Dynalift C-43 – Increased Displacement

This document should be read together with “CCG 3613 054 - DC01_PA1 - Dynalift C-43 Hull Scantling”.

The vessel was originally designed for a mass (displacement) of 10 tonnes. It has later been found that a more realistic displacement is 12 tonnes. Consequently, relevant and the most critical load cases are updated and the structure is reanalysed for the updated displacement.

Figure 1. Updated sea pressure.

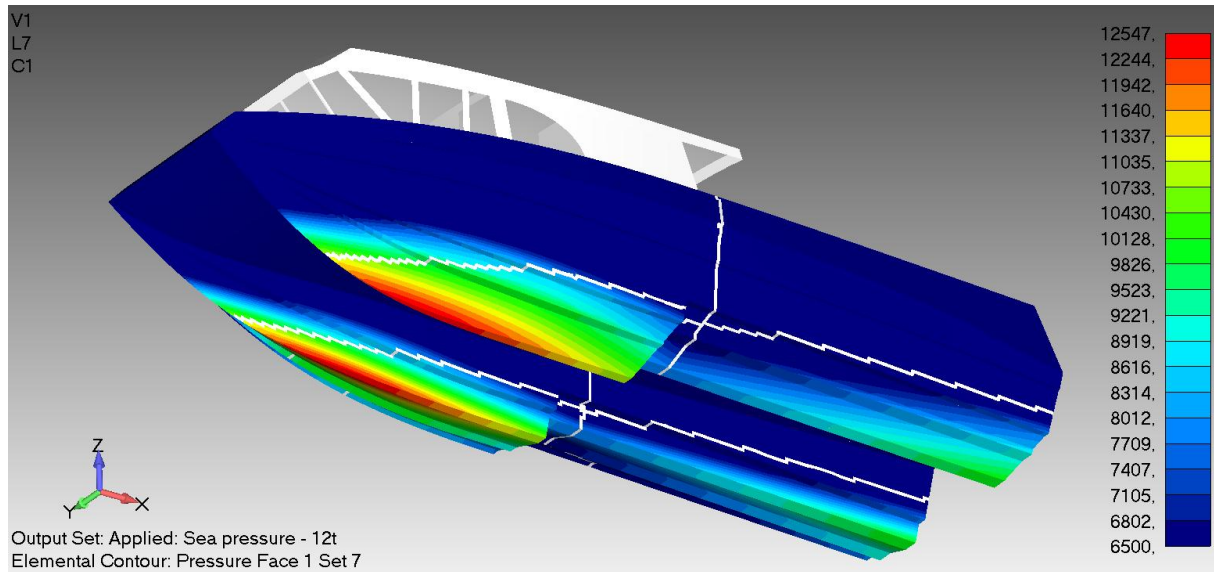
The sea pressure does not have a linear relationship with displacement and is therefore not straightforward to analyse. The new block coefficient is 0.62, compared to 0.51 for the previous value. This gives an overall lower sea pressure (maximum value is decreased by 13%). It is considered that the increased draught (which is not accounted for here) does not give an increase significantly above 13%, and therefore the sea pressure needs not be re-analysed.

Figure 24. Detail of internal highest loaded areas.

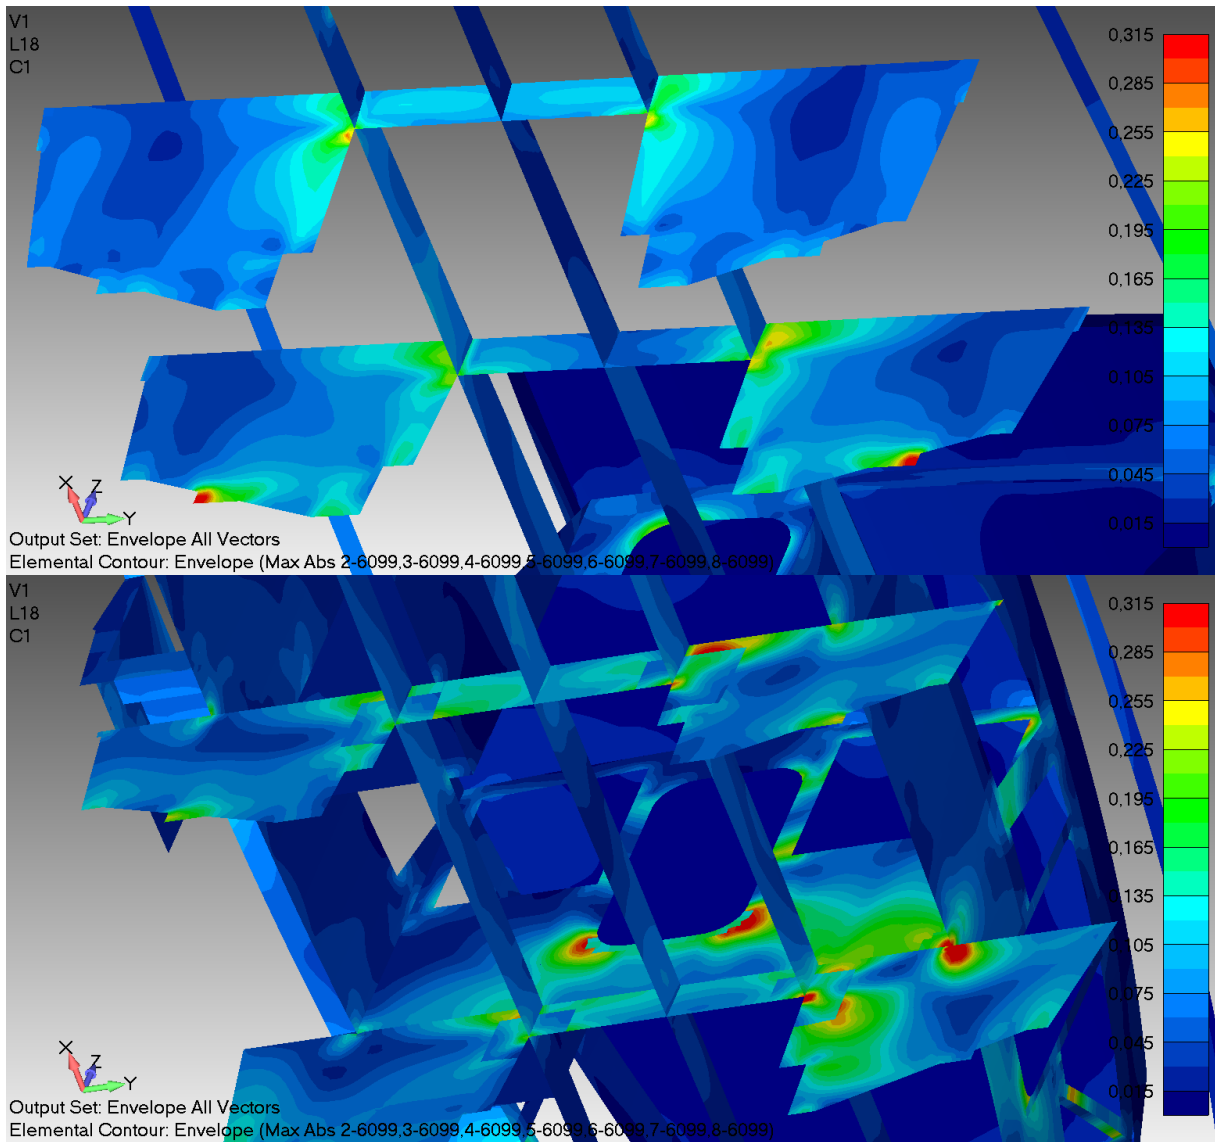
The internal structure is highest stressed from the outwards split moment, where the bulkheads directly below the deckhouse are above allowable at some locations, see detailed view in Figure 24.

Figure 26. Updated bulkhead laminate reinforcement. Upper view shows old layup.

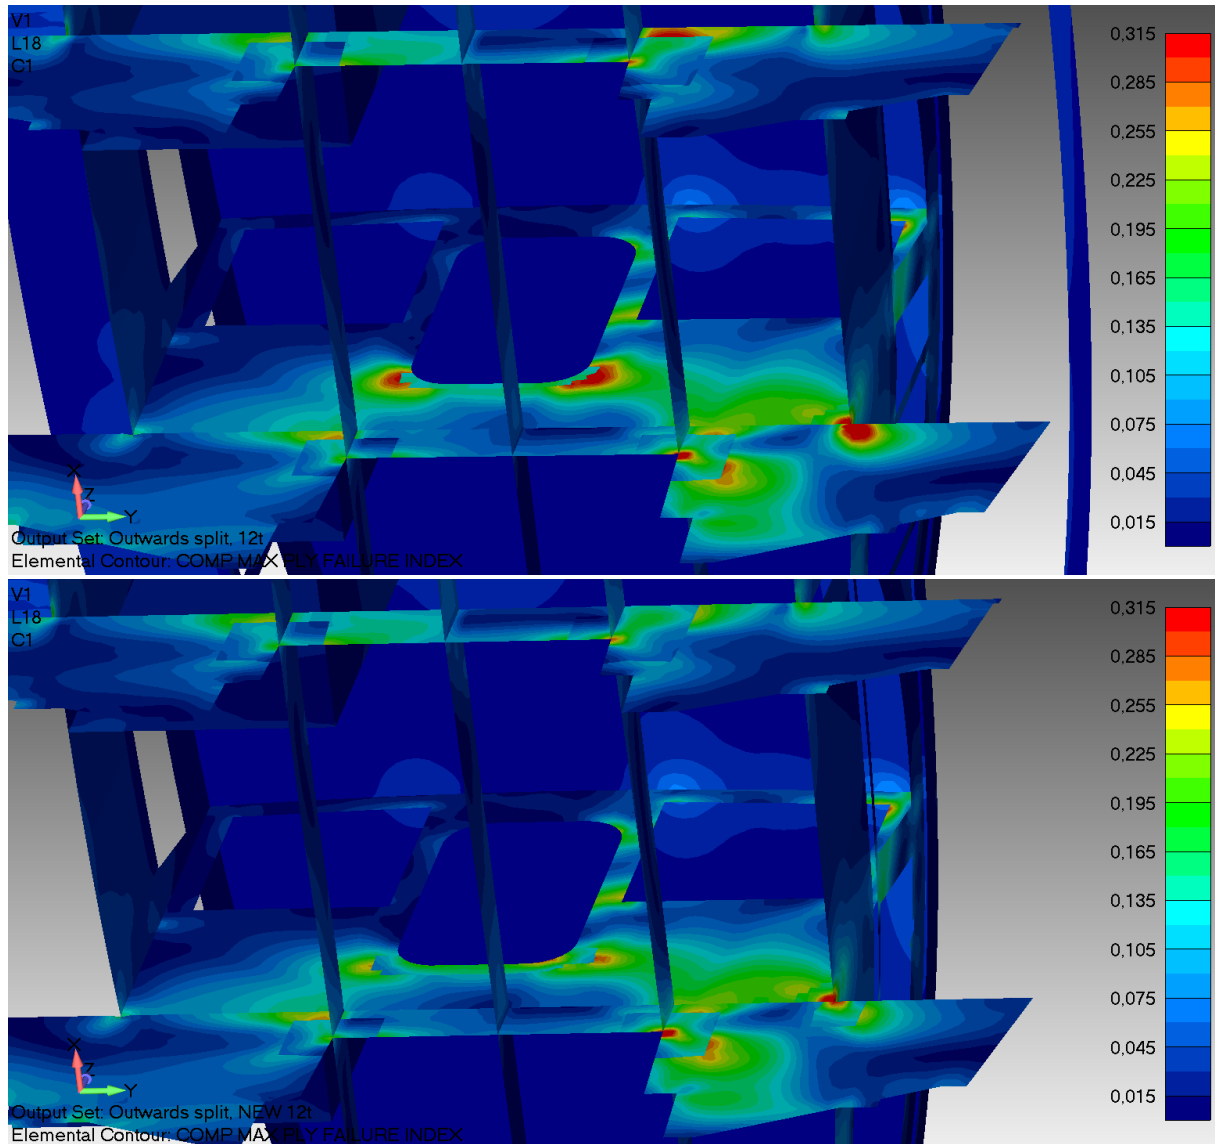
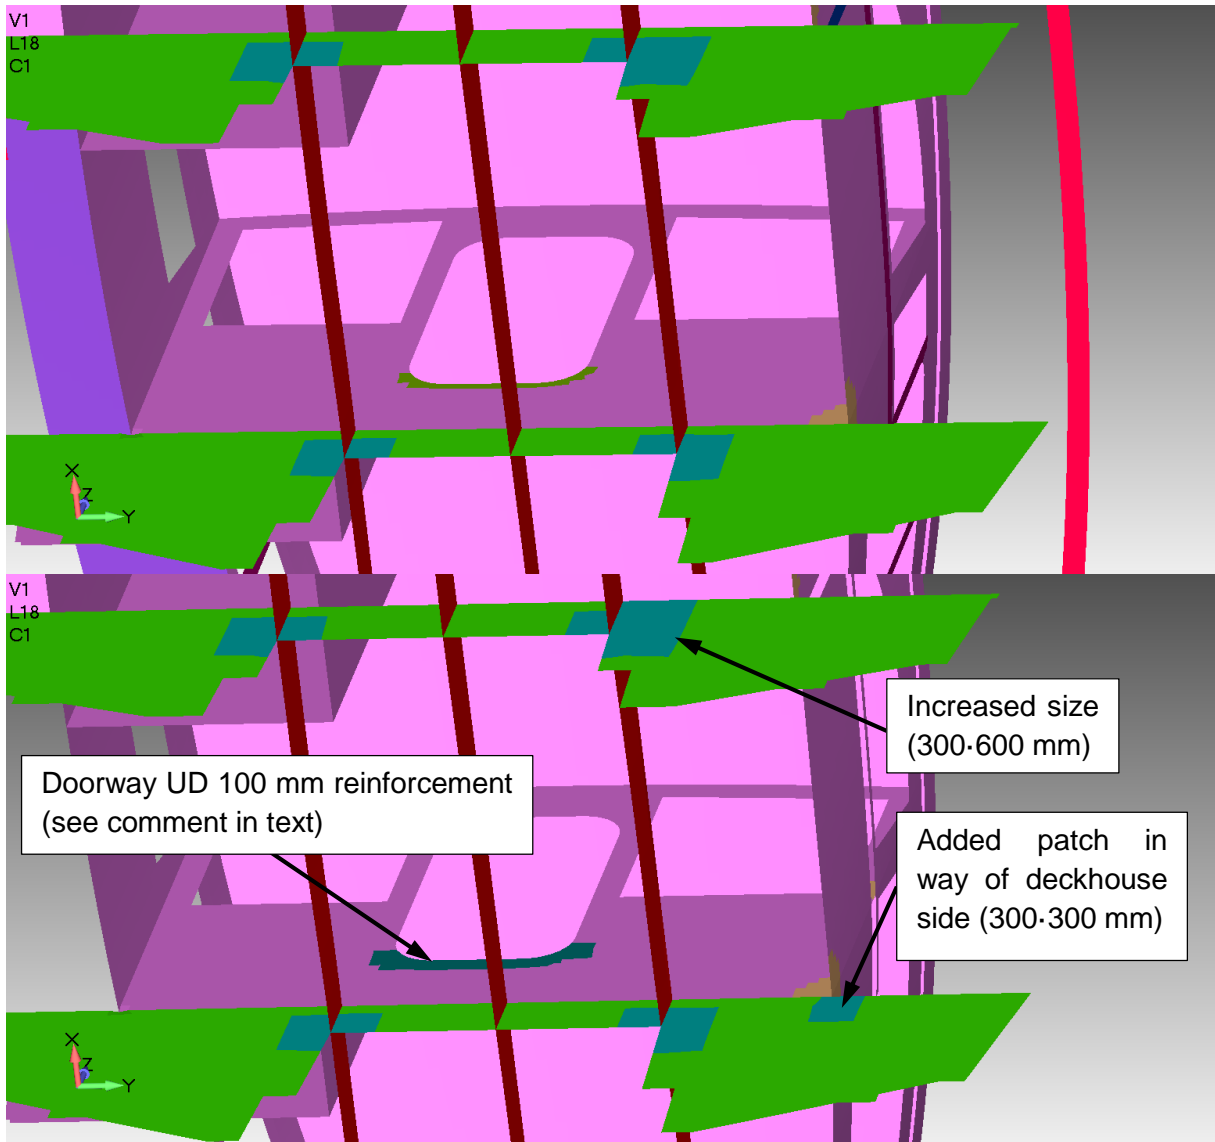
Bulkheads #3 and #4 are updated according to the Figure 26.

It is recommended to taper the ends of the UD plies below the door, see “alternative 2” in the original scantling document (last figure). These should preferably run full thickness 150 mm past the doorway before tapered off. The UD tape to be minimum 100 mm wide and fibre direction across the door (global Y-axis).

The bulkheads below the deckhouse (3:rd and 4:th from transom) need to be reinforced in addition to what is shown in the original 10 tonne scantling document, see Figure 26.

Colour code	Component	Layup sequence	Estimated thickness [mm]
	Doorway UD reinforcement	[CSM300 / UD2400, 100mm / DBLT800 / CSM300 / H60, 20 mm / CSM300 / DBLT800 / UD2400, 100mm / CSM300]	24.0

Table 1. UD reinforcement layup below doorway.
